Indicates changes to approved planning application 2019/6088/P and approved LBC 2019/6270/L

Project
65 Kingsway - Base Scheme

Title
Proposed Ground Floor Plan

Drawing No.
1914-BG-01-00-DR-A-20.202

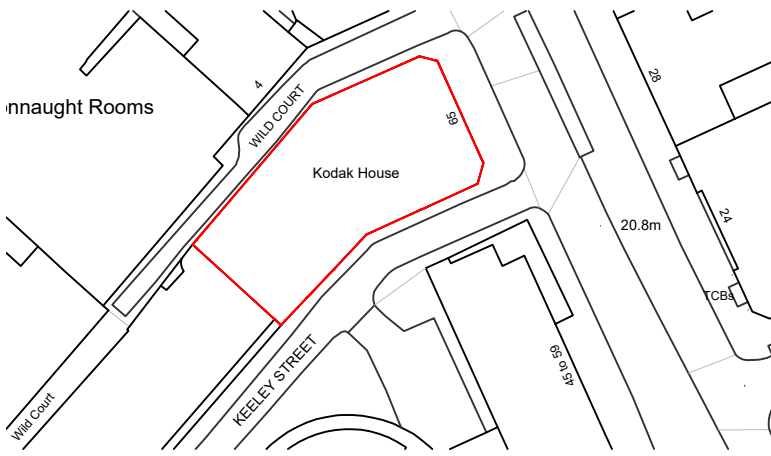
- A. F/F Lift omitted and Goods Lift in place from Basement to Ground Floor level
- B. Revised primary core layout. Lift bank shifts 300mm to GL/5 and WC's layout amended to suit.
- C. New cantilevering platform lift with minimum pit depth
- D. Adjustment to Soho Coffee bin store layout
- E. Location of electrical riser changed
- F. Reception design layout amended
- G. Riser wall shifts out by approx 160mm.
- H. New partition wall and door
